3 Building Envelope Requirements

- Comment [VELUX1]: Fenestration includes skylights, according to the definitions in the Standards.
- Deleted: fenestration
- Deleted: minimum
- Deleted: window-to-wall ratio

Figure 3-1 – Slope of a Window (Roof or Skylight slope is less than 75°)

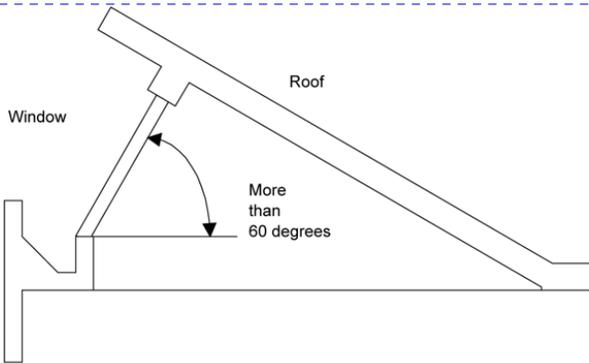
Comment [VELUX2]: Follow Part 2, Chapter 24 definition of vertical glazing. (Figure 3-1 should be updated accordingly)

Figure 3-3 Examples of Dynamic Glazing Integral Shading Devices

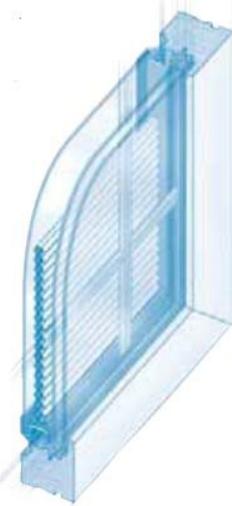
Comment [VELUX13]: This figure should either be removed as it is not complete, or a second graphic representing the added type of NFRC-approved dynamic glazing should be added.

Comment [VELUX16]: Remove or add supplemental graphic.
